SUBJECT: Supplement B to the Application for Certification
Hidden Hills SEGS (11-AFC-2)

Response to Data Adequacy Review

**Hidden Hills Solar Electric
Generating System
(HHSEGS)**

(11-AFC-02)

Attachment B1
Figures 5.2-1R and 5.2-2R

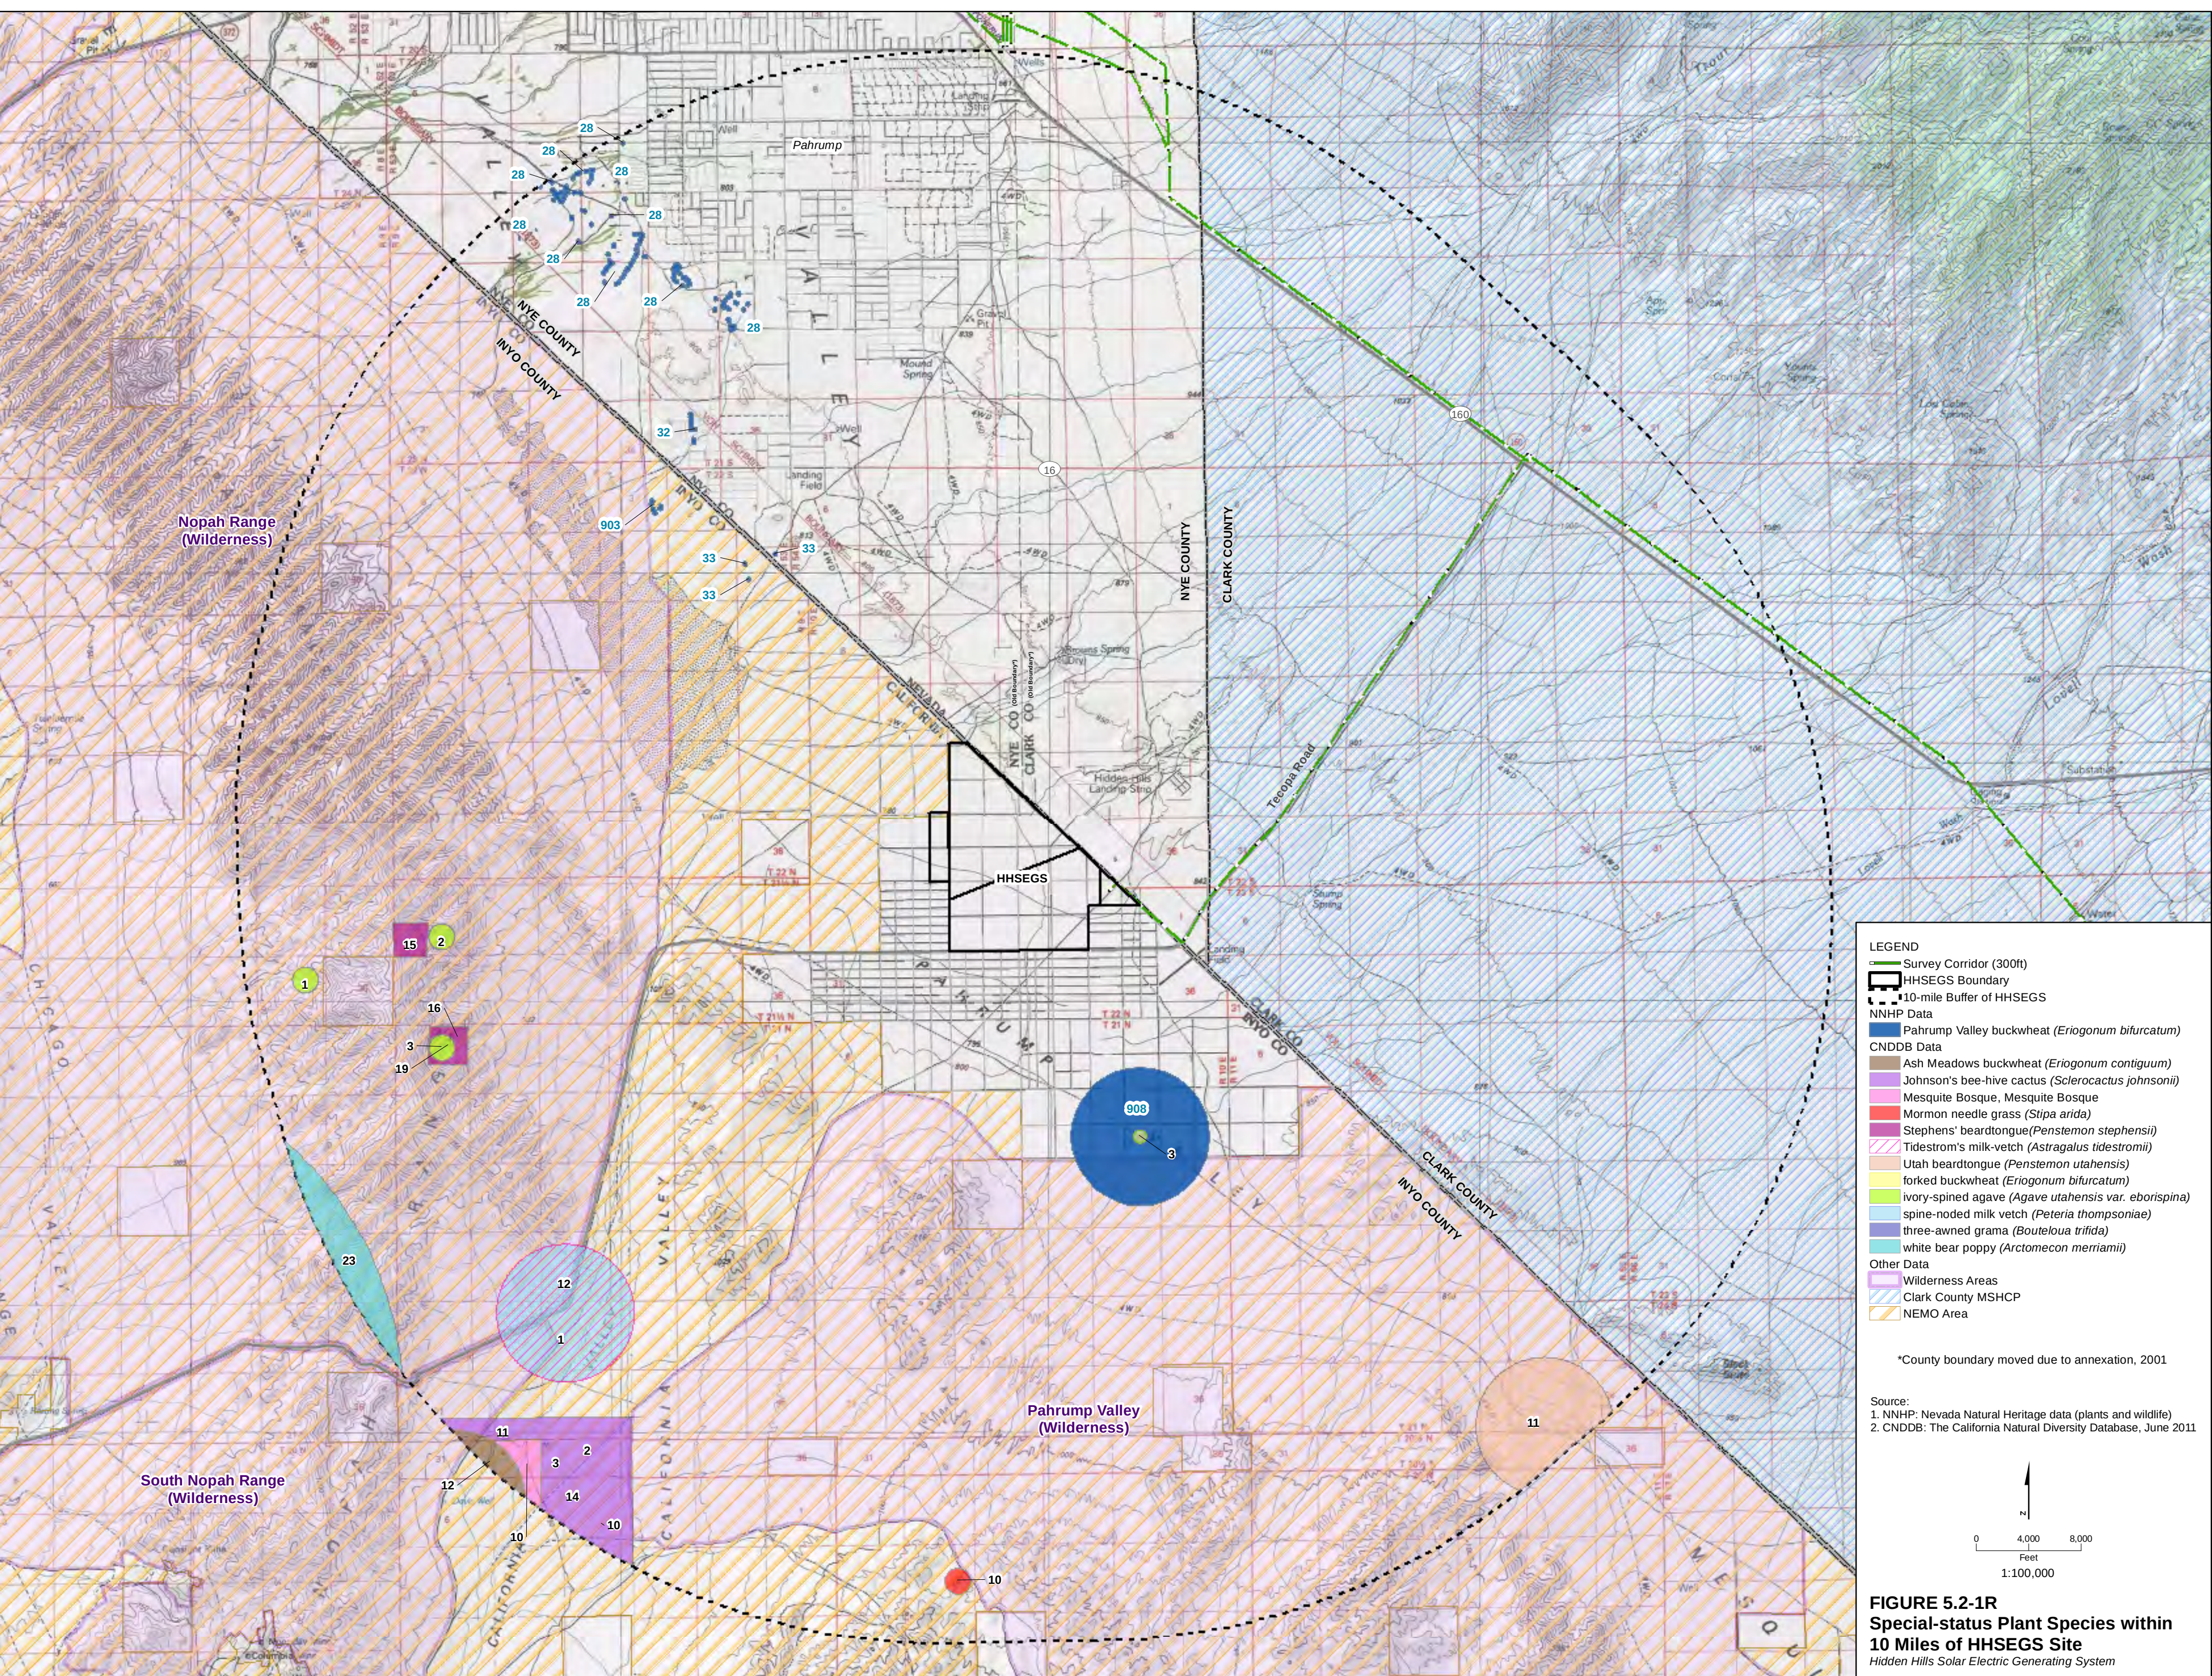
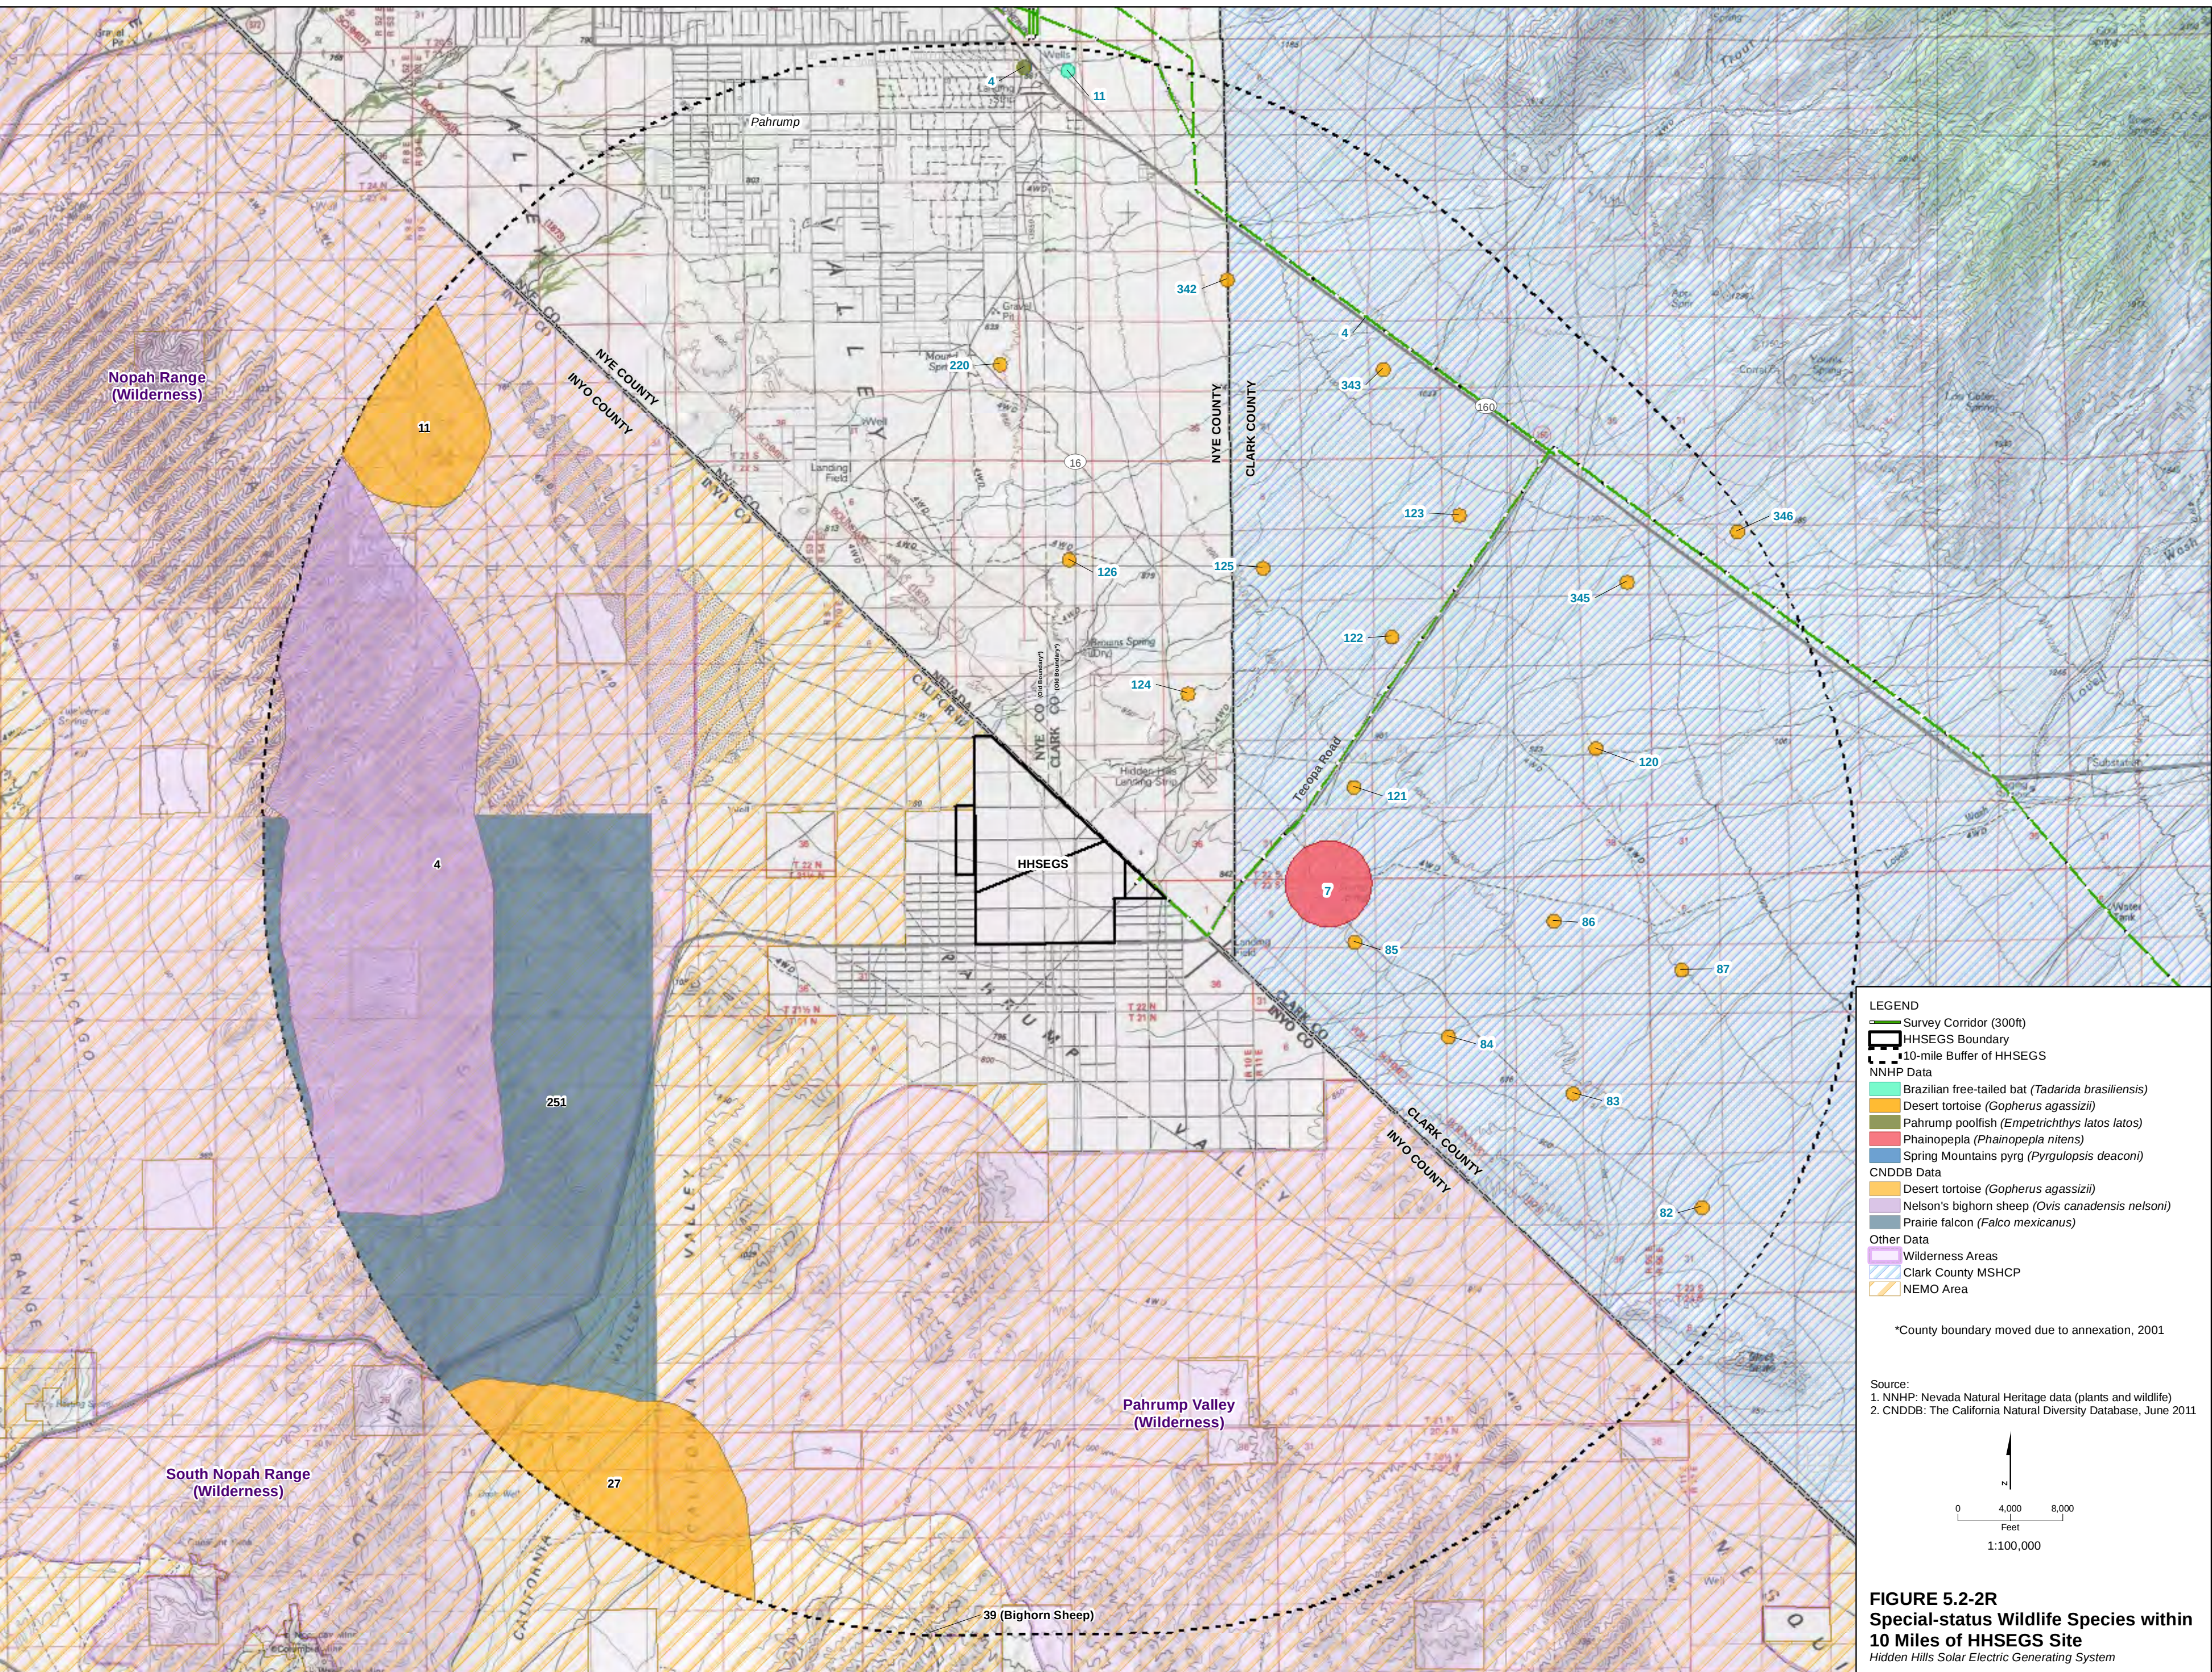
Please provide a map at 1:100,000 scale of ~~sensitive biological resources~~ within 10 miles of the project site and related facilities and any boundaries of a local Habitat Conservation Plan or similar open space land use plan or designation. Please provide the following information for a regional overview map: NEMO regional management layers, Clark County HCP layer, the Nopah Wilderness Area, South Nopah Wilderness Area, and Pahrump Wilderness Area.

Response- AFC Figures 5.2-1 and 5.2-2 have been reprinted at the 1:100,000 scale with the requested information added. They have been renumbered as 5.2-1R and 5.2-2R. Five sets of the figures are being provided to CEC staff as Attachment B1. Electronic copies will be provided to others upon request.
